NOTICE OF REVISION (NOR) **CONTINUATION SHEET**

DATE: 030827	ECP NUMBER: BRI-U4353	NOR SHEET NUMBER: 2	NOR NUMBER: 3
CAGE CODE: 19207	DOCUMENT NUMBER: 12389717	DOCUMENT TITLE: PLATE, FRONT, SLOPE, WELDMENT

8. DOCUMENT NO. 12389718	
12. CONFIGURATION ITEM (OR SYSTEM) TO WHICH ECP APPLIES HOWITZER, MEDIUM, SELF-PROPELLED, 155MM, M109A2-A5/A6/M992				11. ECP NO. BRI-U4353

SECTION C-C
SCALE 1/1

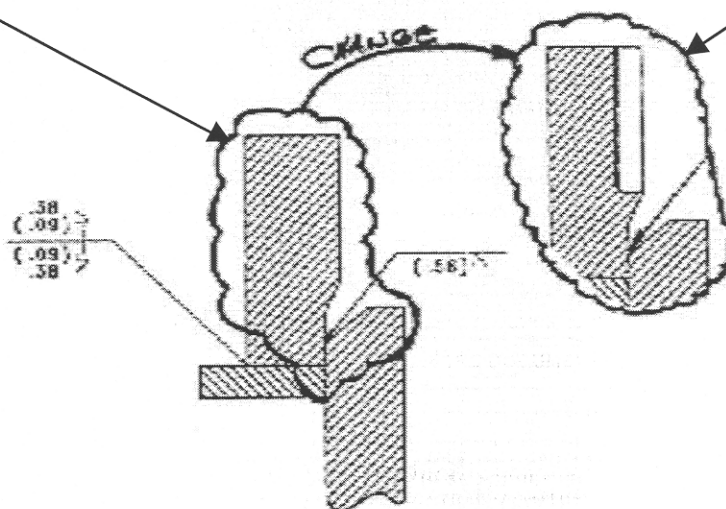
ZONE D,E-16,17,18

ZONE E,F,G-10,11

CHANGE PICTORIAL OF SECTION C-C AS SHOWN BELOW

ZONE D,E-11,12

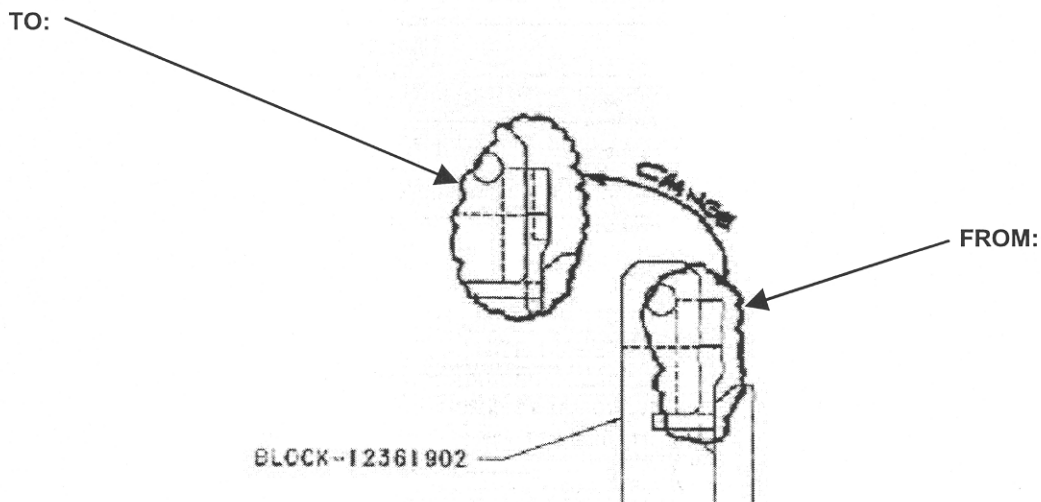
CHANGE PICTORIAL AS SHOWN BELOW

ZONE D,E-6,7

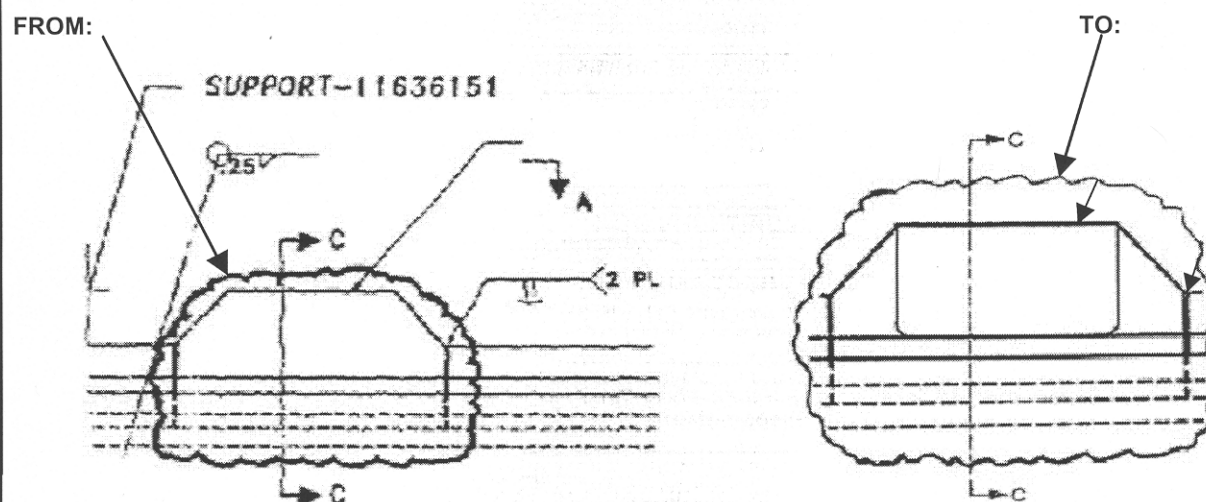
CHANGE PICTORIAL AS SHOWN BELOW

ZONE F.G-5,6,7

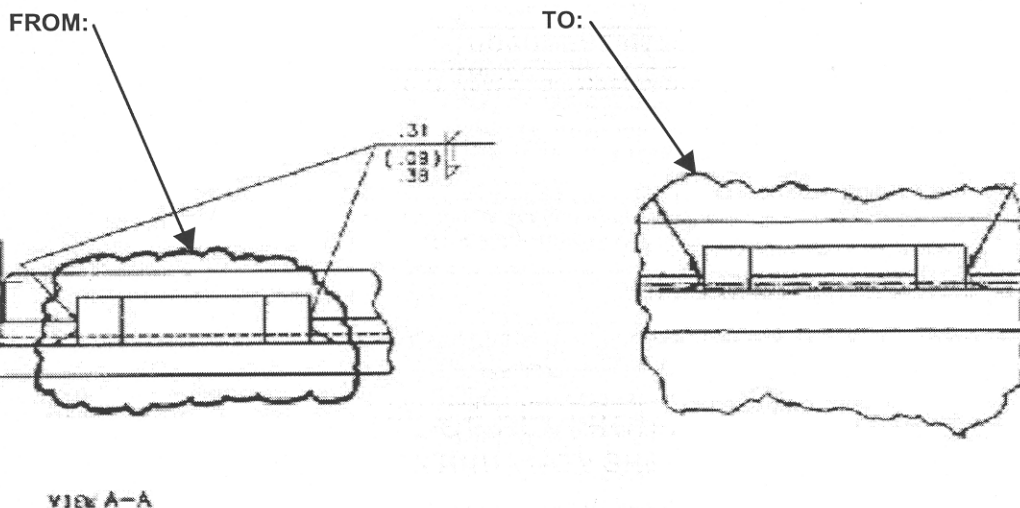
CHANGE PICTORIAL IN VIEW A-A AS SHOWN BELOW
